APPLICANT: CAMFORD PROPERTY GROUP, INC 37 EAST CENTRAL STREET FRANKLIN, MASSACHUSETTS COVER SHEET PANTHER WAY FRANKLIN, MASSACHUSETTS PREPARED FOR CAMFORD PROPERTY GROUP, INC. 37 EAST CENTRAL STREET FRANKLIN, MASSACHUSETTS FEBRUARY 19, 2020 SCALE: 1" = 100'

Re: Panther Way Site Plan and Special Permit Application Peer Review

On behalf of the applicant Camford Property Group, Inc. we have provided responses to the following comments from the Franklin Town Engineer, Franklin Town Planner, Franklin Fire Department and BETA Group, Inc. The review comments are listed below and our response are immediately following each comment and have been italicized.

Re: Panther Way Site Plan and Special Permit Application Peer Review

FRANKLIN, MASSACHUSETTS

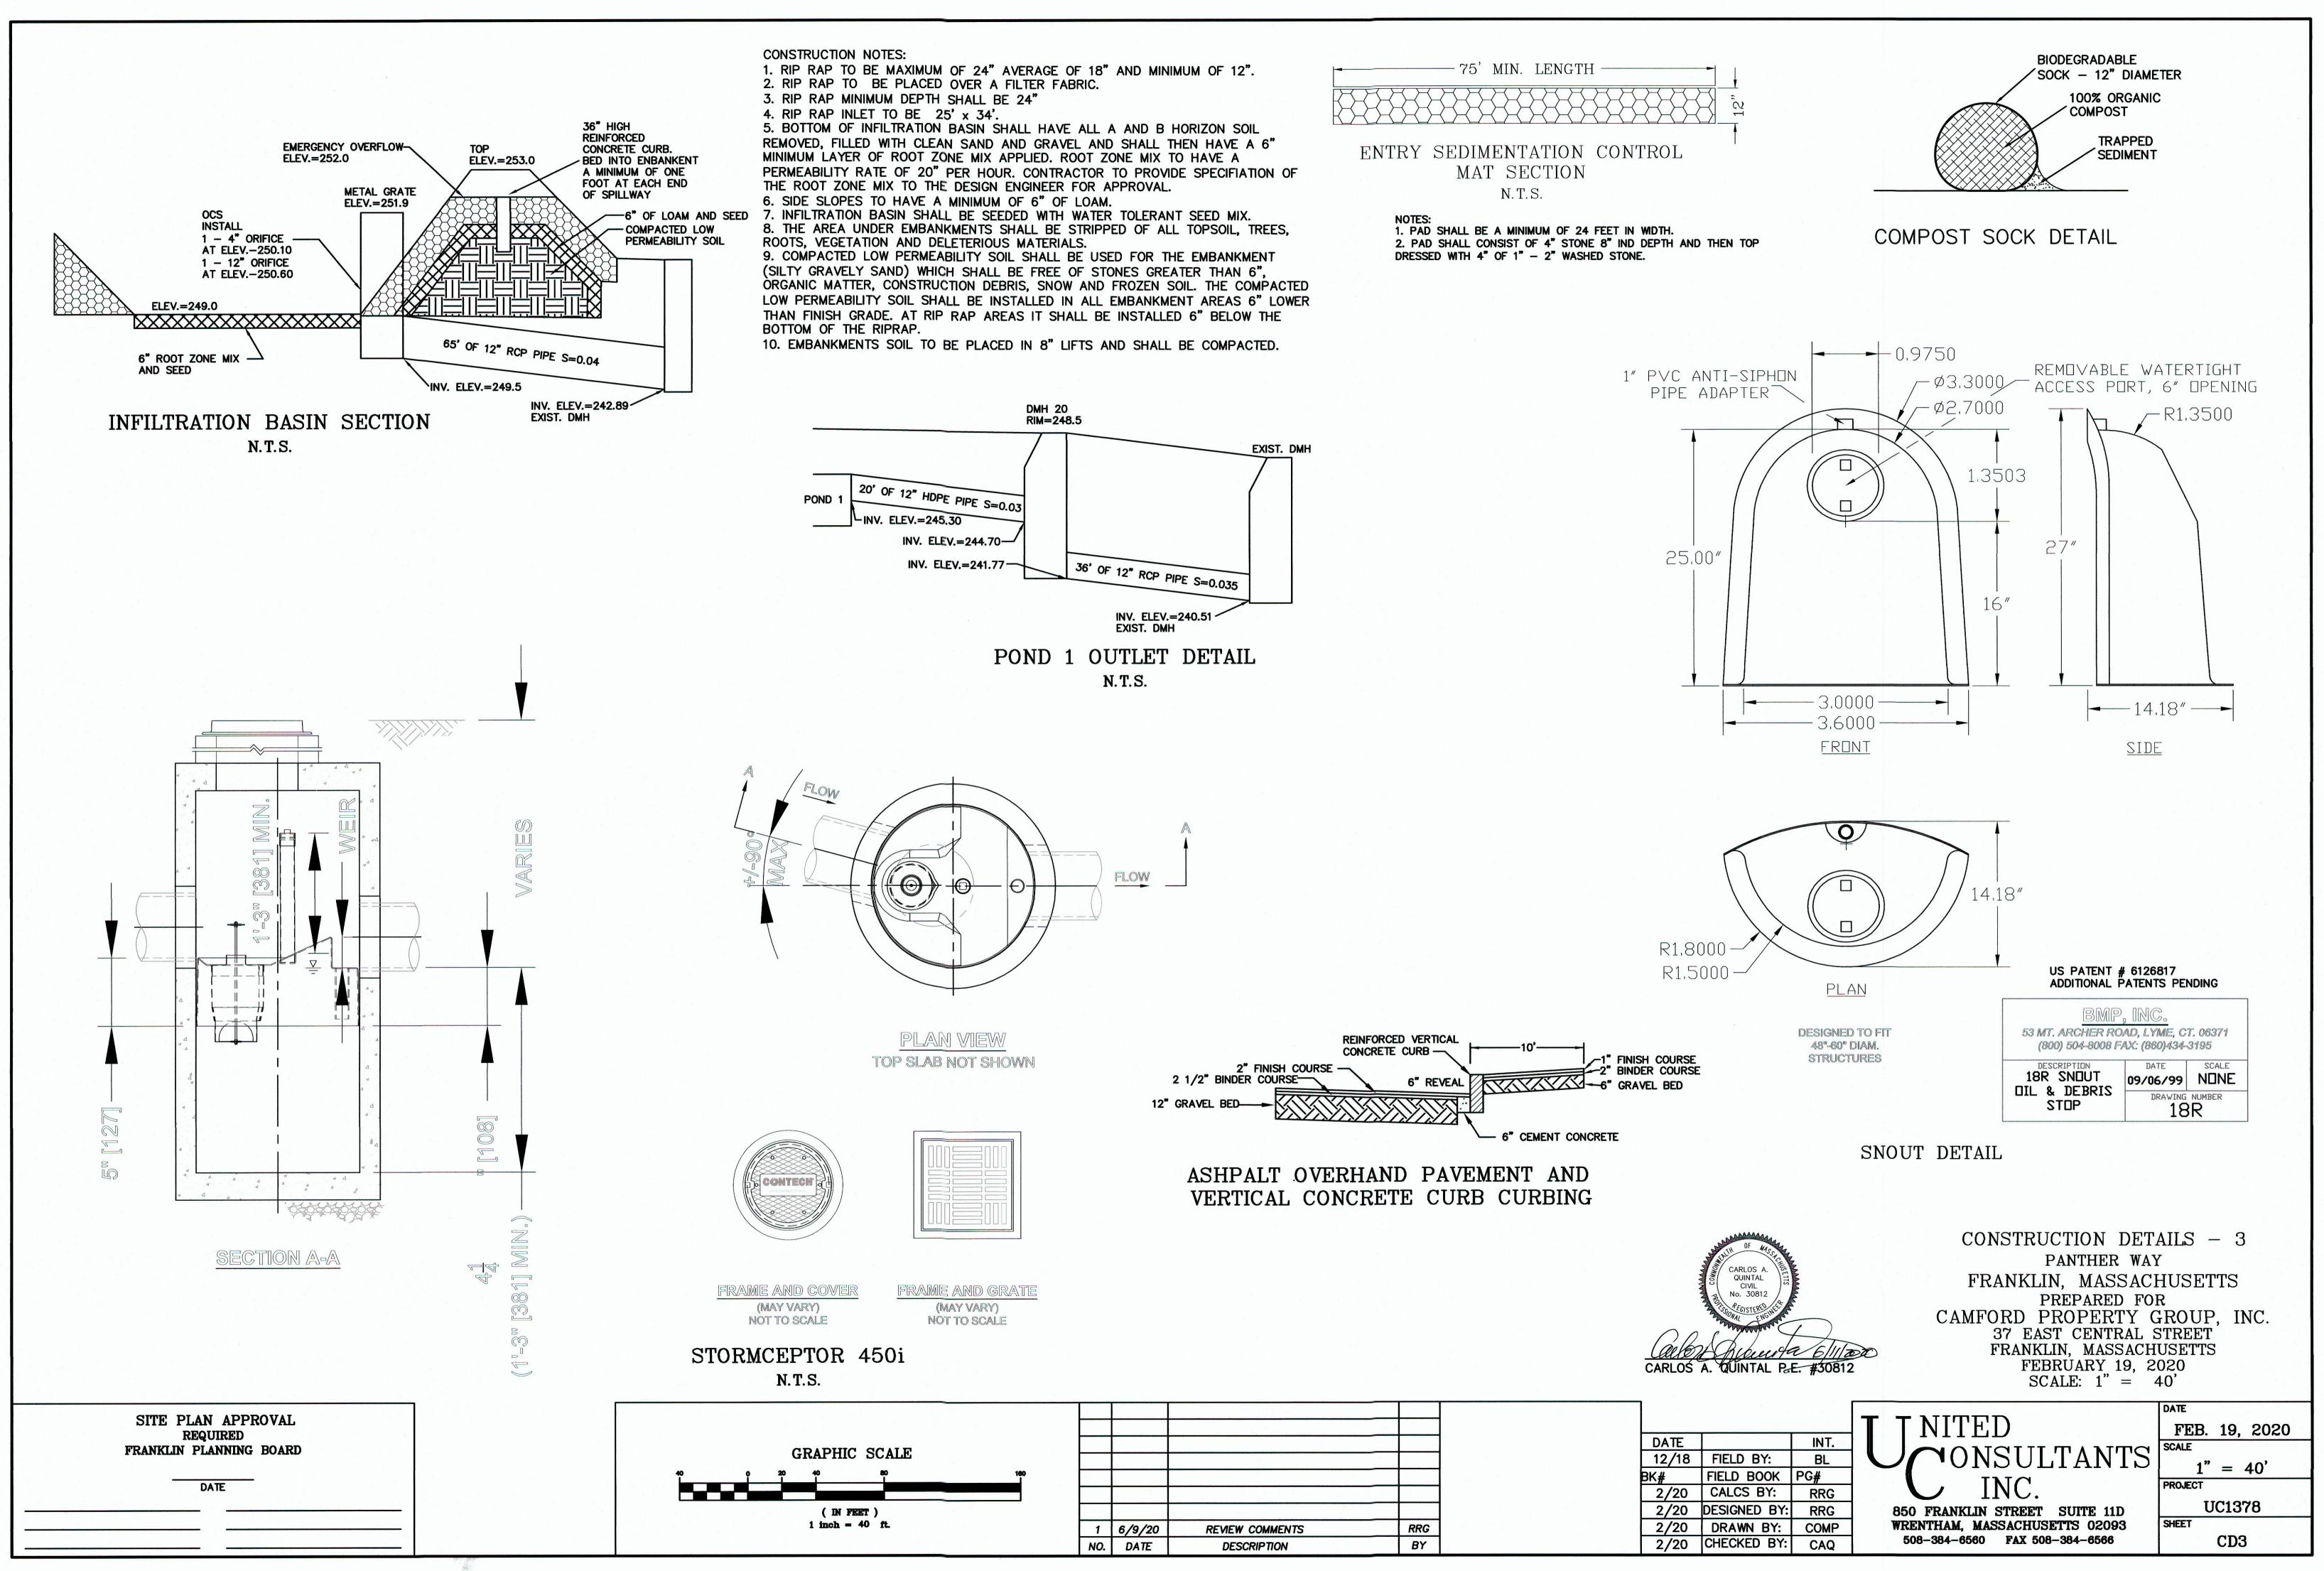
- **3.** The Erosion Control Plan indicates that slopes steeper than 3:1 shall be stabilized with hydroseed, geotextile fabric, or riprap as required. We recommend that slopes *equal to or* greater than 3:1 be stabilized as noted. *The note has been revised on sheet ERC1.*

SW9. Clarify the erosion control line/limit of work. It is clearly depicted at the northeast corner of the site; however, the end of the erosion control line is not readily visible.

SW10. Clarify construction sequence notes on sheet ERC1. There are two separate sets of notes.

The erosion control line has been made wider on sheet ERC-1. Additional labels were added to each end of the limit of work line on sheet PP1.

The notes have been revised.
